Response to

Request for Additional Information No. 378(4409, 4513, 4490), Revision 2, Supplement 7

U. S. EPR Standard Design Certification
AREVA NP Inc.
Docket No. 52-020
SRP Section: 06.02.01 - Containment Functional Design
SRP Section: 06.02.02 - Containment Heat Removal Systems
SRP Section: 06.02.03 - Secondary Containment Functional Design

Figure 06.02.01-87-28 — Temperatures of Containment Wall at an Elevation of +93.51ft, near the Location of Maximum Temperature

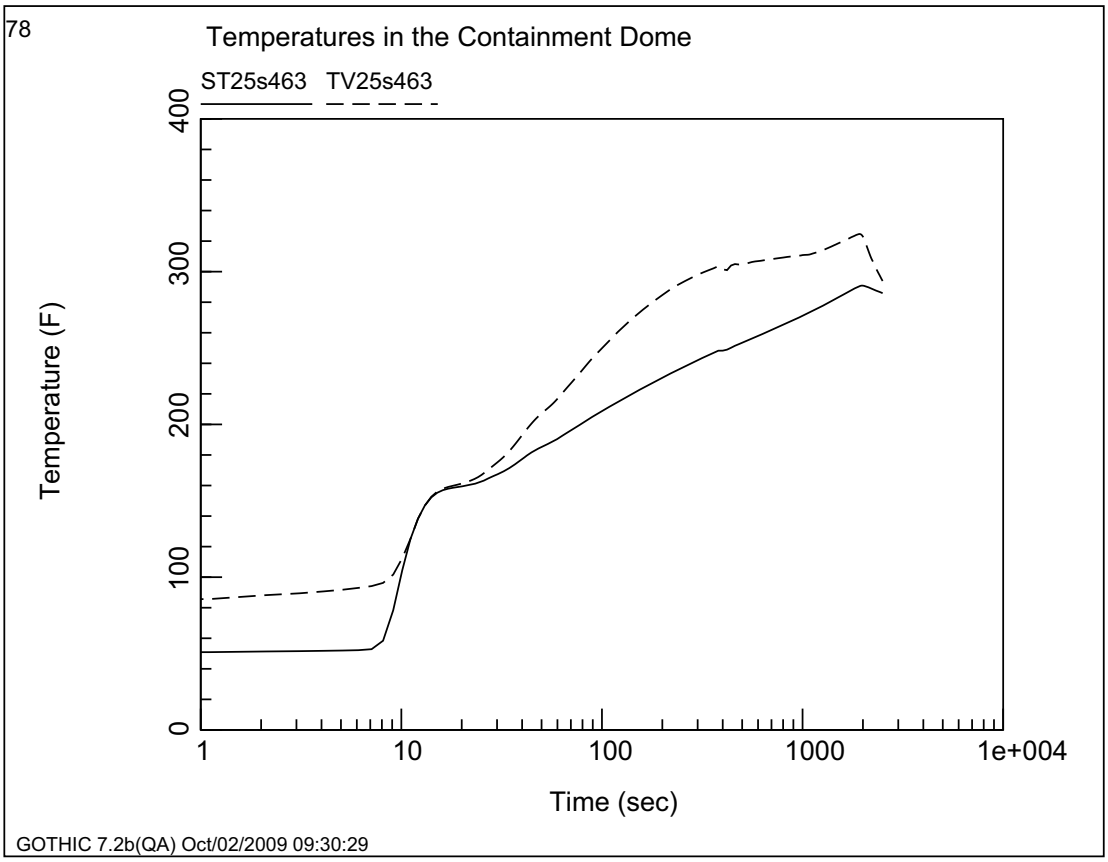
f) Time history atmospheric temperature plots for subdivided nodes in the dome region nearest the containment centerline (19 vertical locations). The atmospheric temperature plots should include both gas (vapor) and saturation temperatures.

f) Figures 06.02.01-87-18 through 06.02.01-87-27 show the time history atmospheric temperature plots for the subdivided nodes nearest the containment centerline.

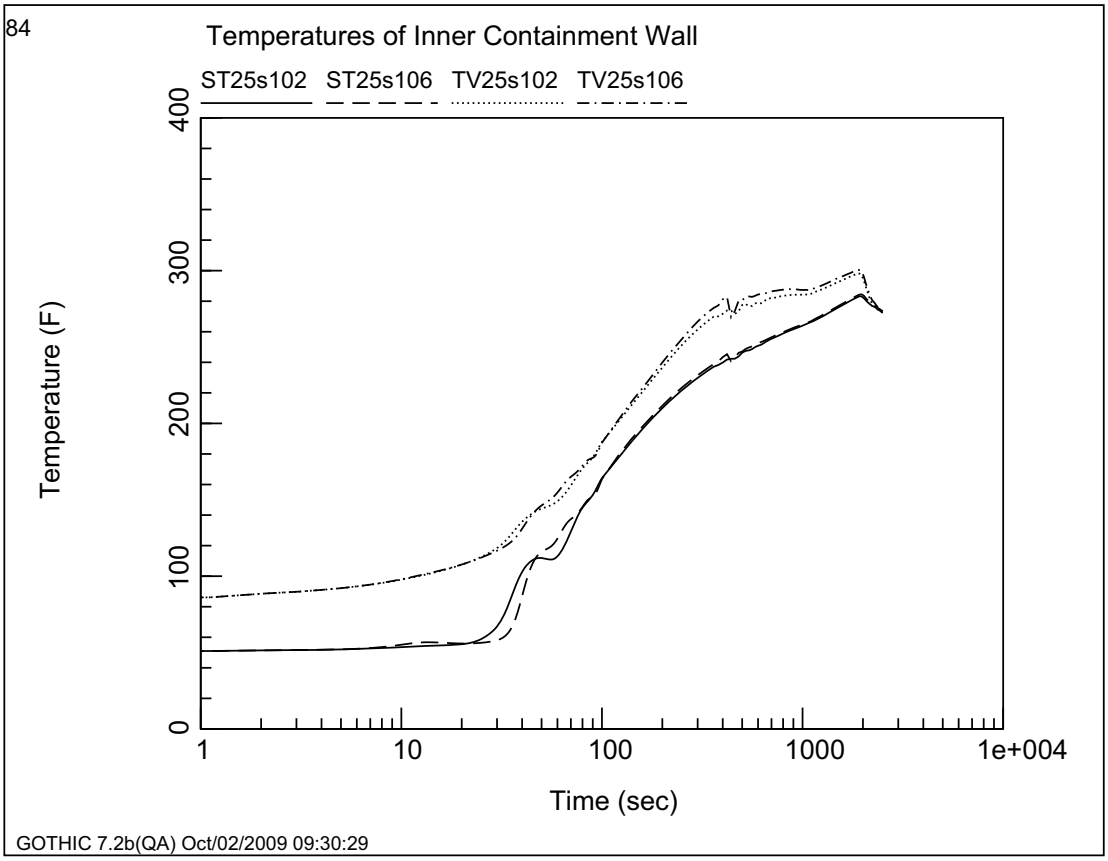
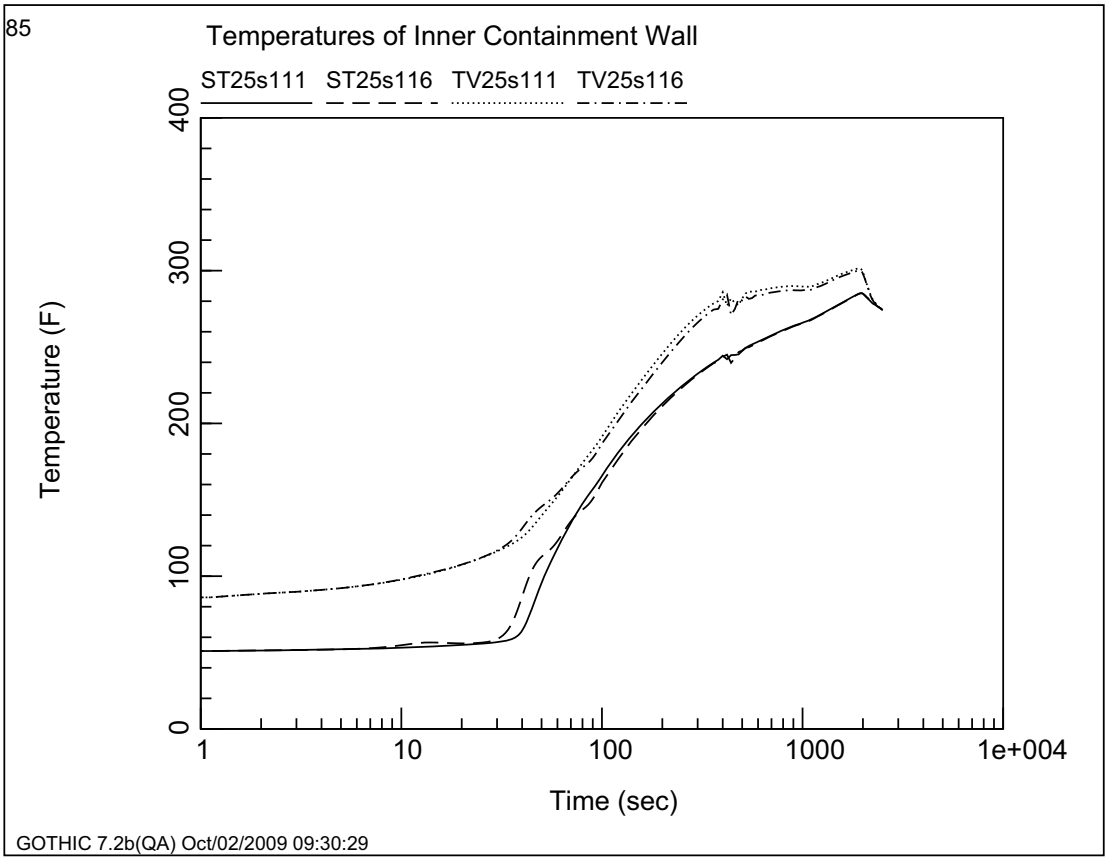
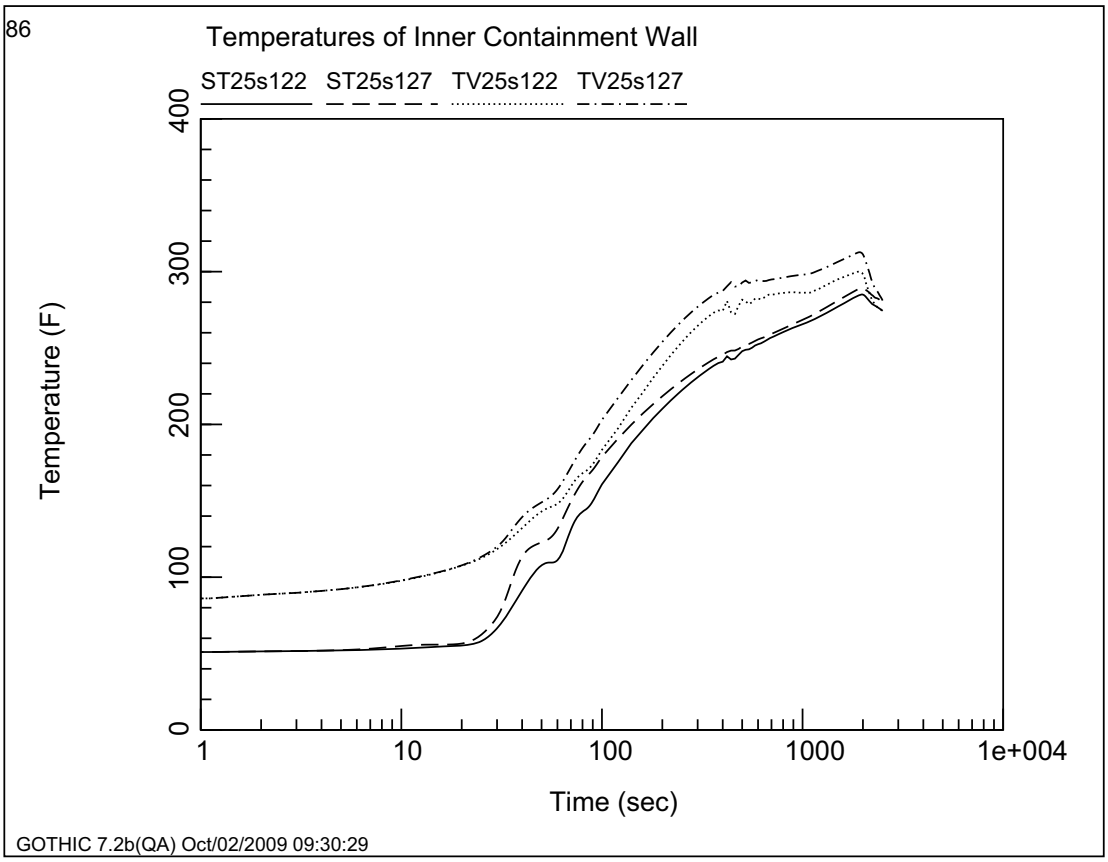
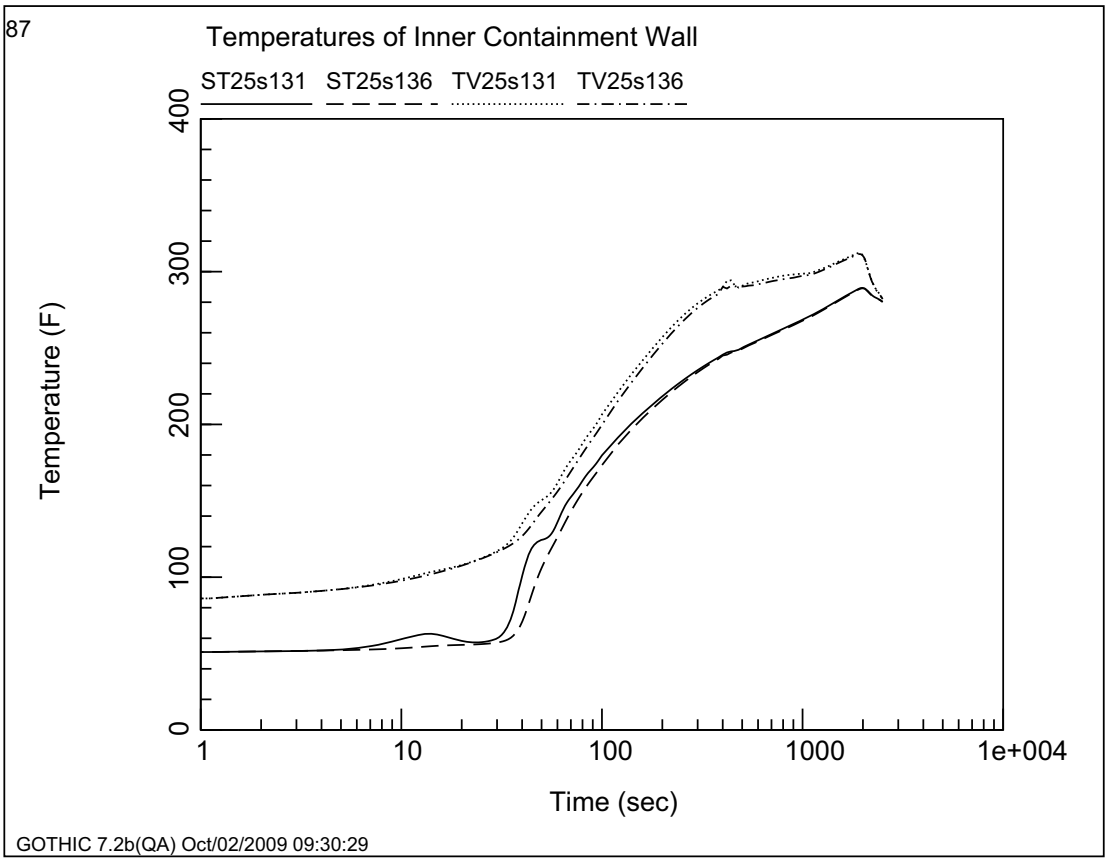
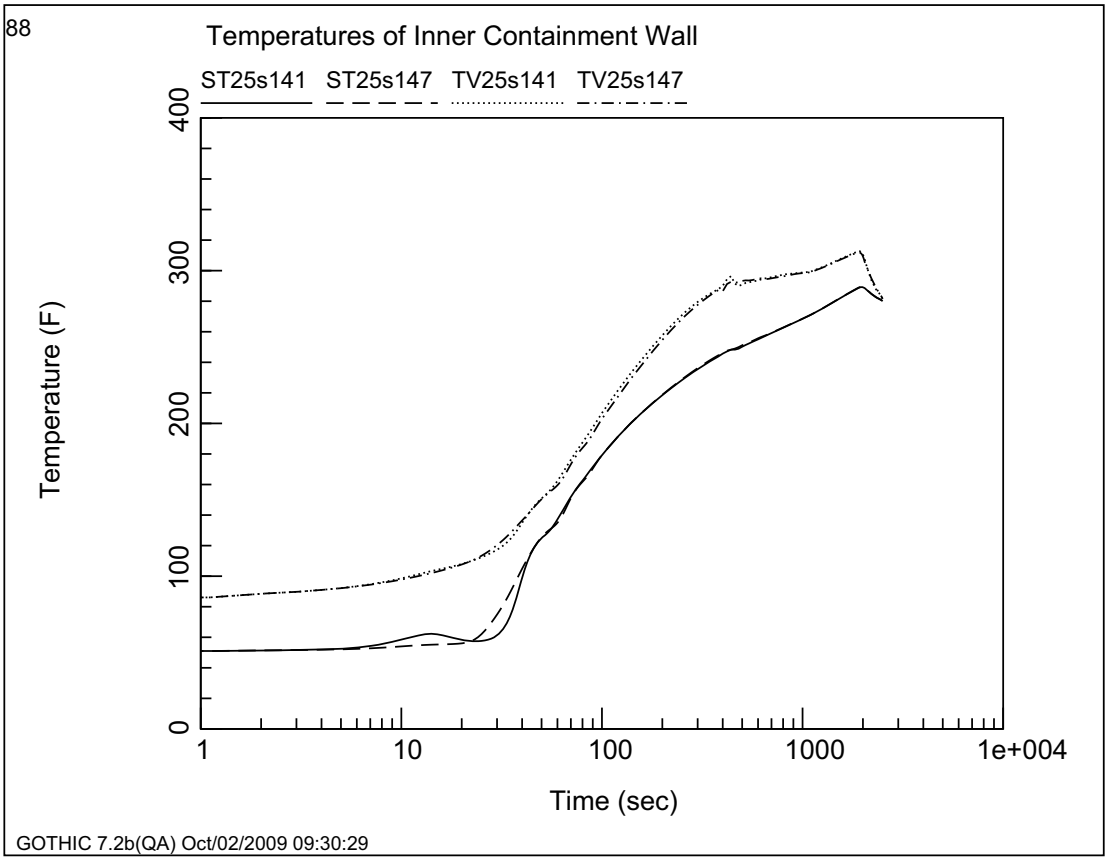
g) A time history temperature plot for the inner containment shell (sub-divided or lumped parameter node in figure) in proximity to the location of maximum atmospheric (gas) temperature

g) Figures 06.02.01-87-28 through 06.02.01-87-32 show the time history atmospheric temperature plots for the subdivided nodes of the inner containment shell in the proximity of the location of maximum atmospheric temperature, Node 7. The inner containment near the location of maximum atmospheric temperature is modeled in Node 25 as subdivided cells.
